Great Western Highway Upgrade  
Blackheath to Little Hartley – EIS Submission  
PO Box 334  
PARKES NSW 2870

1 March 2023

#### **Great Western Highway Upgrade: Blackheath to Little Hartley EIS (SSI-22004371)**

**Proximity of Greaves Creek Catchment to Blackheath portal and construction zone. SIX Maps, NSW Govt.**

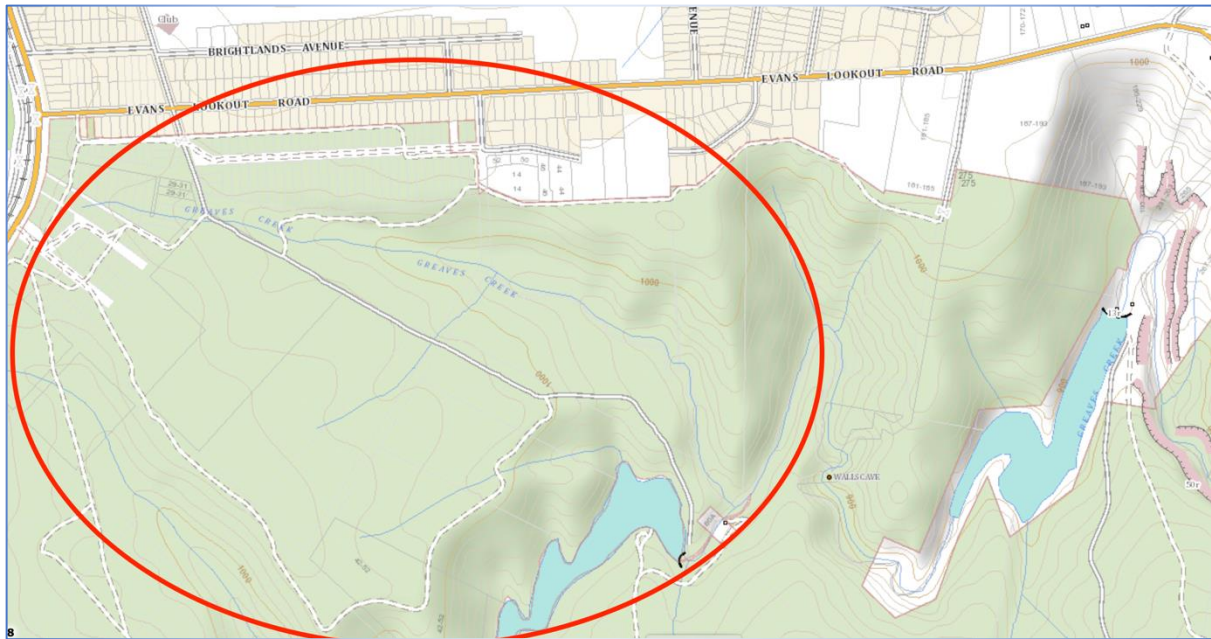
Of great concern is the Greaves Creek system due to its proximity to the Blackheath portal (see map below). The Greaves Creek system comprises THPSS that contain confirmed populations of Giant Dragonfly (*Petalura gigantea*) and Blue Mountains Water Skink (*Eulamprus leuraensis*), both endangered groundwater-dependant species.

The map highlights the proximity of the Greaves Creek system to the highway corridor and clearly shows that the headwaters of this system are within the middle of the proposed Blackheath construction site. This area on the east of the GWH is also a designated Sydney Water Special Area. The *Blue Mountains Special Areas: Blackheath, Katoomba* are protected because they collect drinking water for the neighbouring Blue Mountains urban populations. According to WaterNSW's Facts Sheet, "Special Areas' are large areas of mostly unspoilt bushland surrounding the reservoirs that provide drinking water for Sydney, the Blue Mountains and the Illawarra. Special Areas are vital to the protection of our drinking water because they help filter out unsafe nutrients and other substances before the water reaches the reservoirs." Because of this role the public is not allowed in these areas. This calls for extra effort to ensure drinking water is not being impacted. [See map at [www.watarnsw.com.au/water-services/water-storage/managing-dams-and-reservoirs](http://www.watarnsw.com.au/water-services/water-storage/managing-dams-and-reservoirs)]
